BULLETIN NUMBER:
SB00-11-S007

CERTIFICATION LABEL PAYLOAD INFORMATION INCORRECT SAFETY CAMPAIGN 00V-258

2000 Hombre (TH) vehicles with the following VIN range: Y8700002 through and including Y8703732

Figure 1: Driver's door

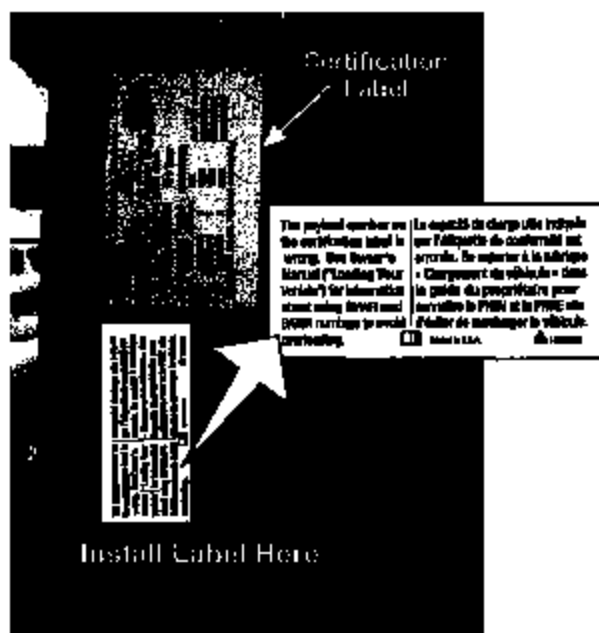
The preferred area of installation of the label is beneath the certification label, however, if this is not possible due to the presence of another label, install the label as near to the certification label as possible.

3. Carefully align the label to the surface of the driver's door. Press firmly and smooth out the label on the door surface. (Figure 1)

NOTE: The label must be uniformly bonded to the entire surface.
